7.6 All Other Instrumentation Systems Required for Safety

The information in this section of the reference ABWR DCD, including all subsections, tables, and figures, is incorporated by reference with the following departures and supplements.

Figure 7.6-4a Basic Configuration of a Typical Neutron Monitoring System Division

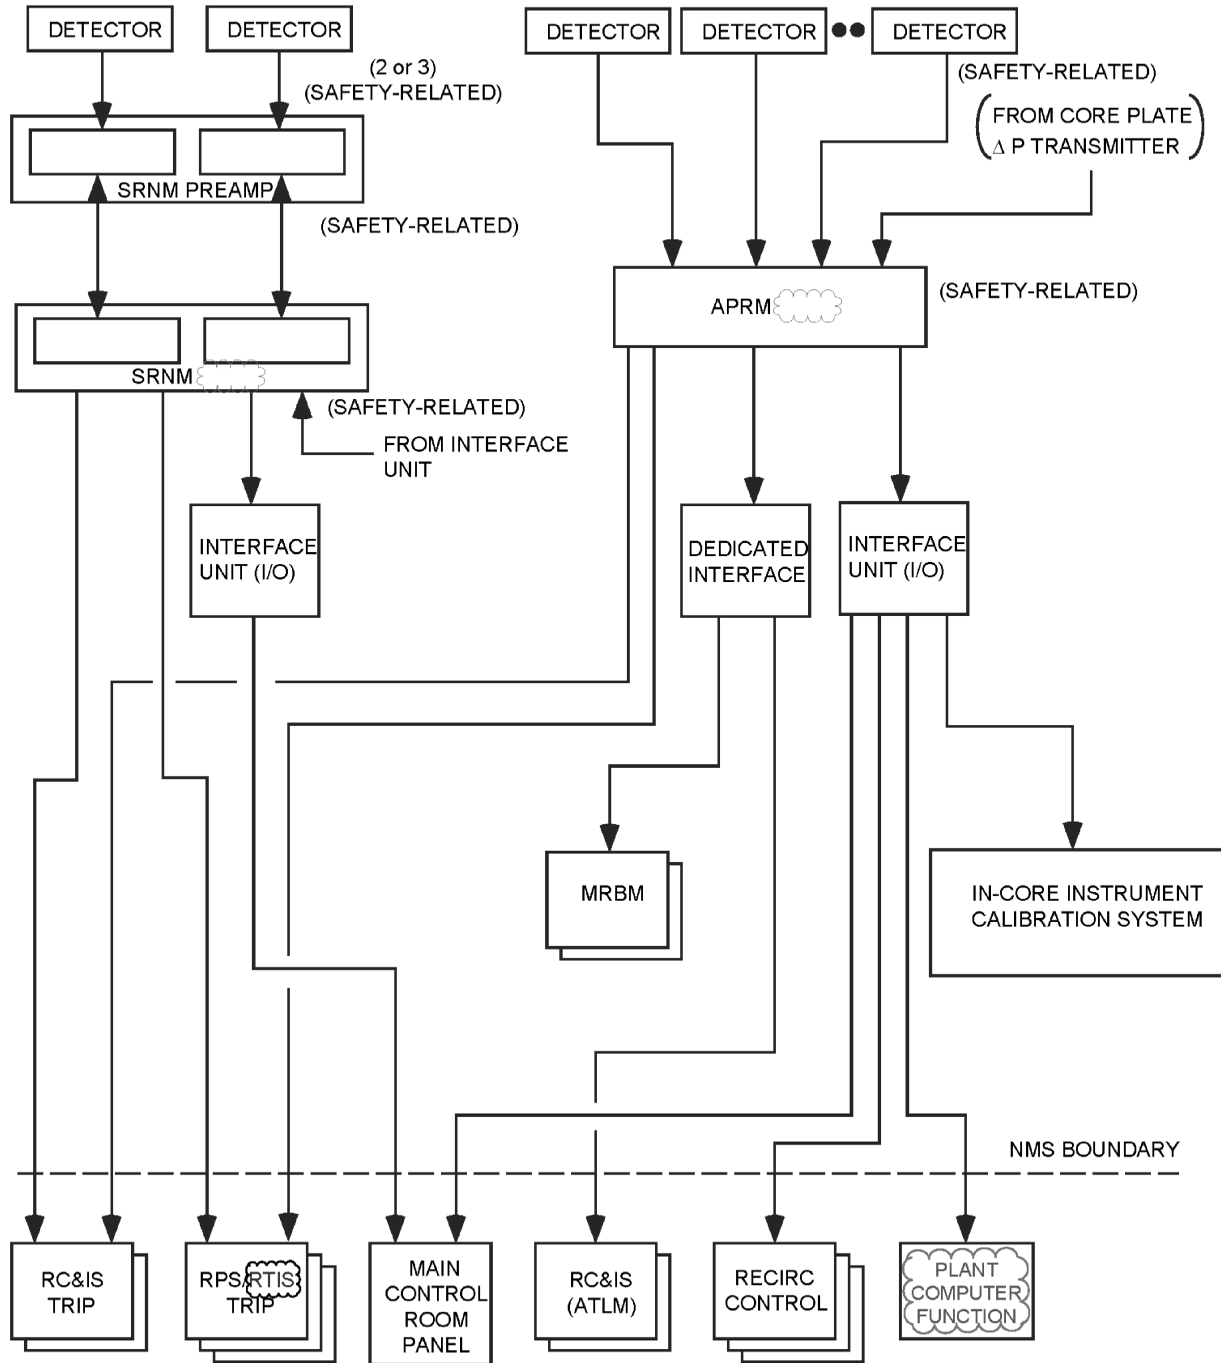
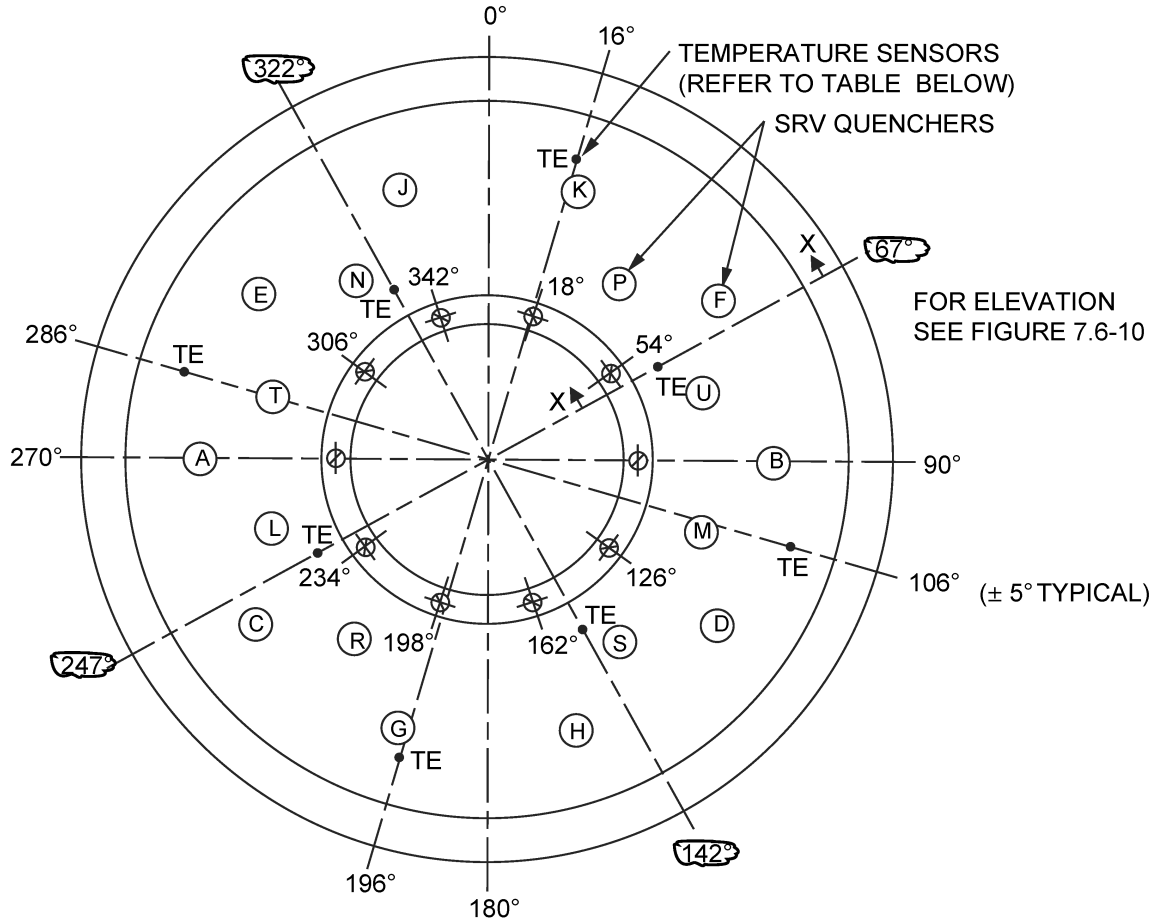
STD DEP T1 3.4-1 (Table 7.6-5 and Figures 7.6-1, 7.6-2, 7.6-4a)

The purpose of the Neutron Monitoring System (NMS) is to monitor power generation and, for the safety function part of the NMS, to provide trip signals to the Reactor Protection System (RPS) to initiate reactor scram under excessive neutron flux (and power) increase condition (high level) or neutron flux fast rising (short period) condition. The NMS also provides power information of operation and control of the reactor to the Plant Process Computer System (PCS) Functions (PCF) and the rod block monitor. A block diagram showing a typical NMS division is shown in Figure 7.6-4a. The operating ranges of the various detectors are shown in Figure 7.6-4b.

Figure 7.6-9 Instrumentation Location Definition for the Suppression Pool Temperature Monitoring System

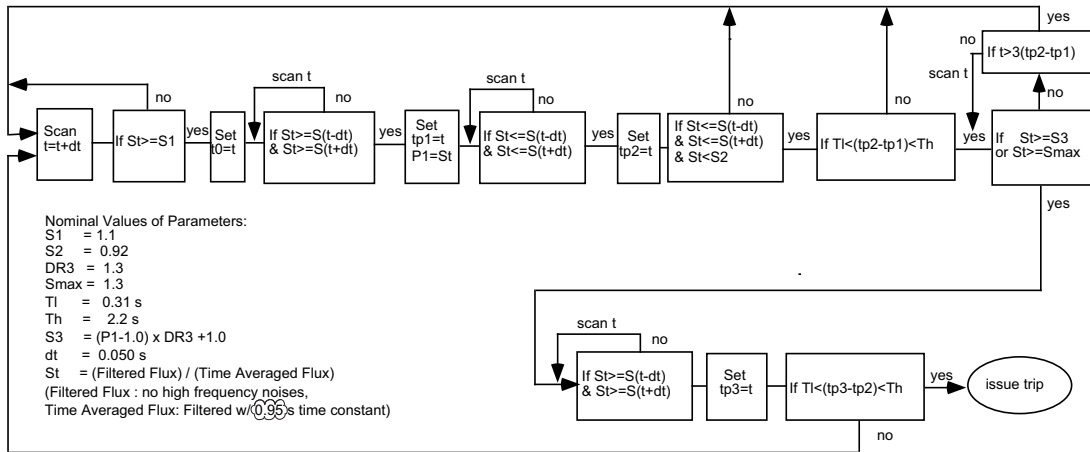
STD DEP 7.6-3 (Figures 7.6-9, 7.6-11)

The SPTM System configuration is shown in Figures 7.6-9 and 7.6-10. There are eight temperature circumferential sensor locations (Figure 7.6-9), which are chosen based upon the following considerations:

- (2) Each SRV discharge line quencher is in direct sight of two sets of temperature sensors within 9 meters.

Figure 7.6-14 OPRM Logic

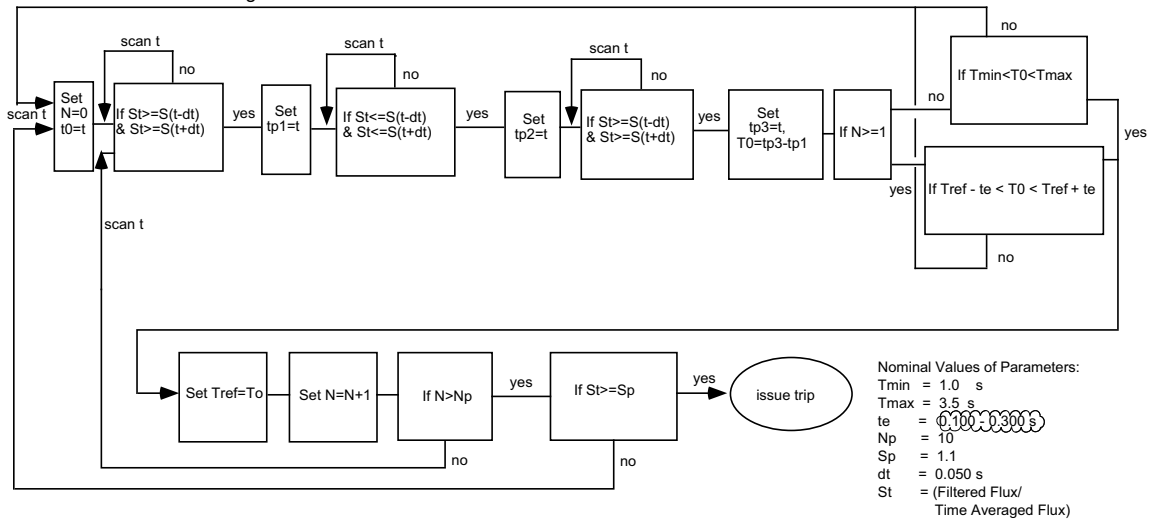
STD DEP 7.6-1 (Table 7.6-2 and Figures 7.6-2, 7.6-14)

For the OPRM trip function, the response signal of any one OPRM cell that satisfies the conditions and criteria of the trip algorithm will cause a trip of the associated OPRM channel. Figure 7.6-14 illustrates the trip algorithm logic. ~~The OPRM trip function does not have its own inoperative trip for insufficient number of total LPRM inputs in the channel. It follows the APRM's inoperative trip of insufficient number of LPRMs.~~ The OPRM function has its own inoperative trip when the channel has less than the required minimum operable cells, when there is an OPRM self-diagnostic fault, when the APRM instrument watchdog timer has timed out, or if there is a loss of power to the APRM instrument.

$T_{\min}=1$ s, $T_{\max}=3.5$ s, $\pm t_{\text{error}}=0.15$ s **[0.100 - 0.300s]**, $N_P=10$.
 (For details see Figure 7.6-14).
